ADDENDUM NO. 1 - OUTLINE AND SUMMARY INFORMATION

Project Name: Grant Street Pedestrian Mall PPA No.: 22-0001
Location: Grant Street from 7th Ave to 11th Ave Date: 4/23/2024

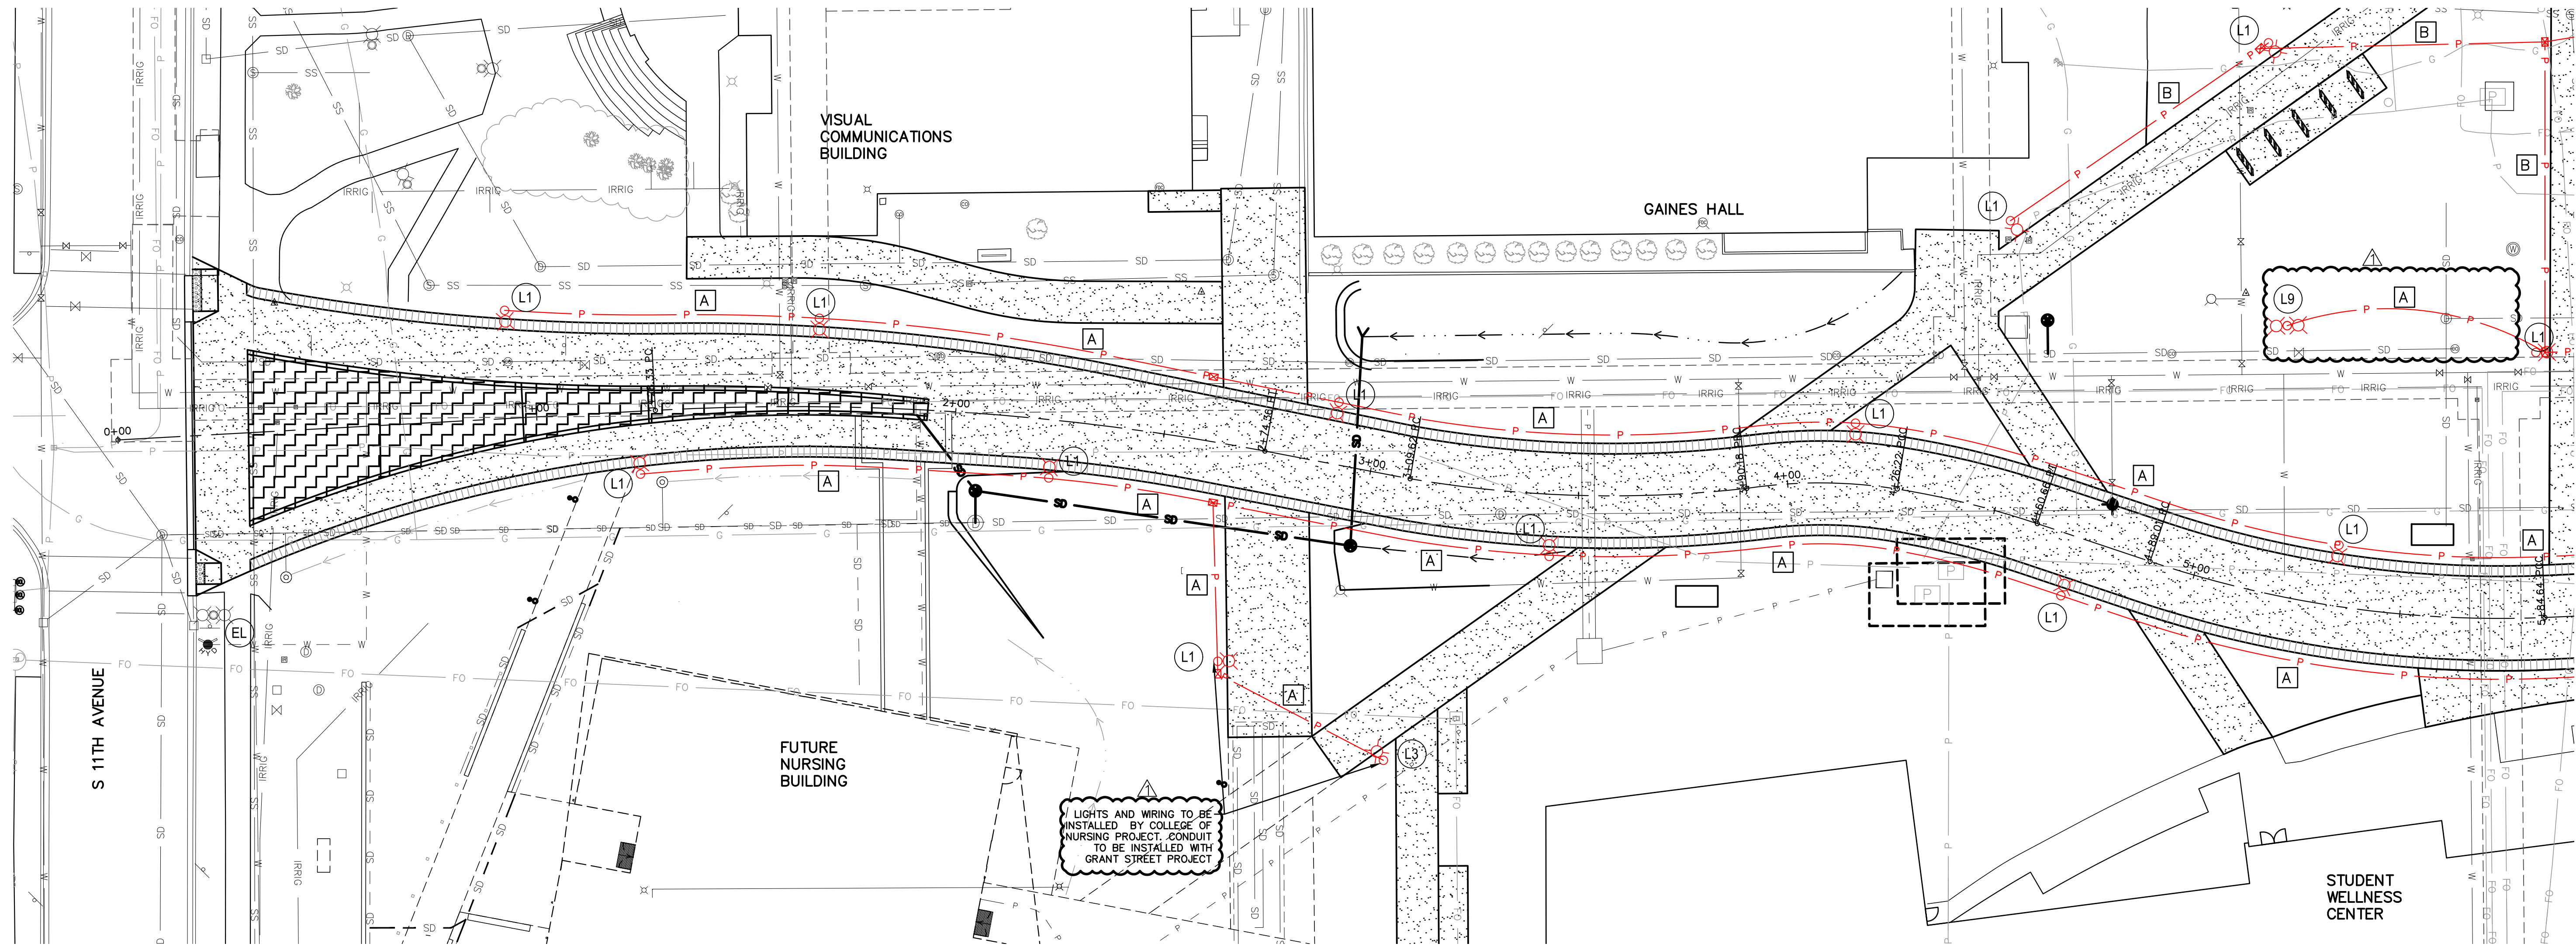
- A. Information has been added regarding minimum specifications for the Electric Service Pedestals.

- A. Power pedestals are to be 100 Amp, with 30 Amp, 50 Amp circuits and 20 Amp convenience level plugins. Provide & install Milbank 5200 series RV pedestal (or equal) containing (1) 50A CS6375 & (2) NEMA 5-20R receptacles. Provide & install feeder, conduit, & base per manufacturer's instructions.

SHEET
E1.1

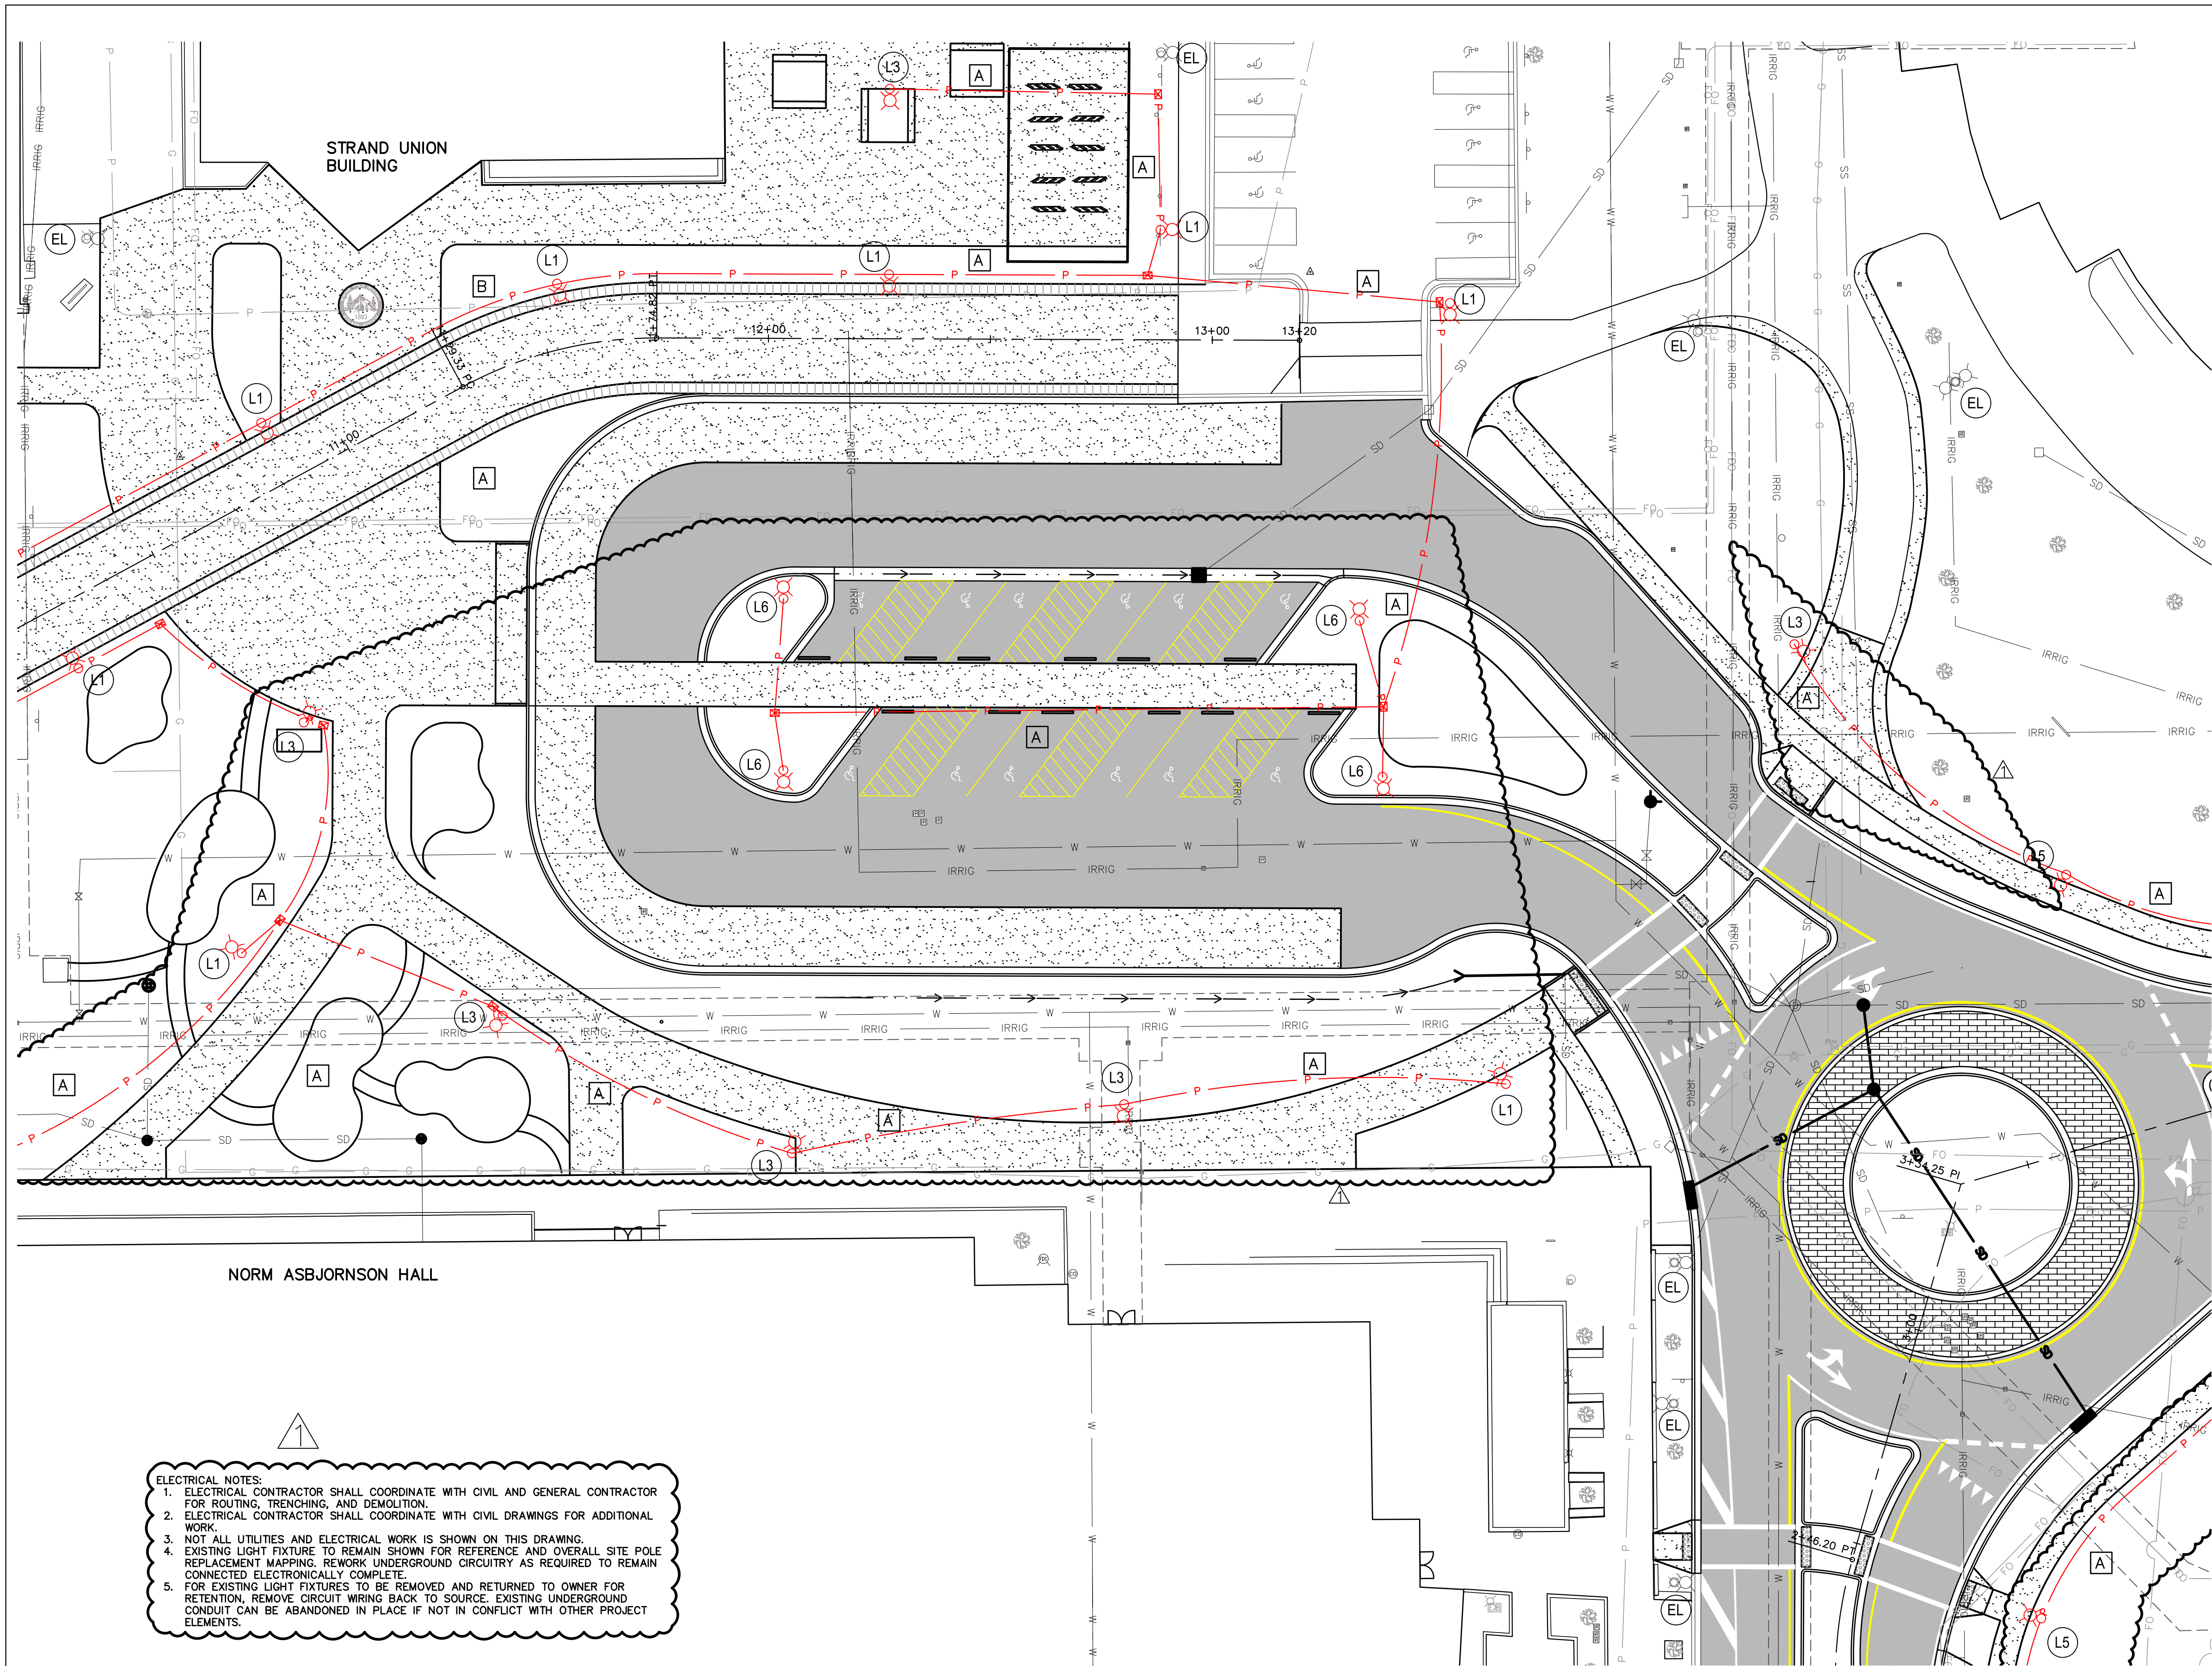
- A. Add note near College of Nursing at Bobcat Circle for 'Lights and wiring to be installed by College of Nursing project. Conduit to be installed with Grant Street project.'
- B. Add new luminaire west of Romney around sitting wall areas.
- C. Light spacing north of Norm Asbjornson Hall has been increased and one luminaire was reduced.

- D. Parking lot luminaires have been modified with new locations and two new units.
- E. Luminaire types and locations have been modified for crosswalk between SUB parking lot and roundabout.
- F. Luminaire types have changed around roundabout and along N 7th Avenue.
- G. Note 5 has been revised to state that existing conduit can be abandoned in place if not in conflict with other project elements. Wiring shall be pulled back to source, but conduit can be abandoned.
- H. Light fixture schedule has been updated to provide new model numbers including the FAWS, Pole Top fitters, TLRD7, CRI 80, fuses in-pole bases per latest edition of MSU Engineering Guidelines.
- I. Details have been added for pull boxes and the electrical service drop.
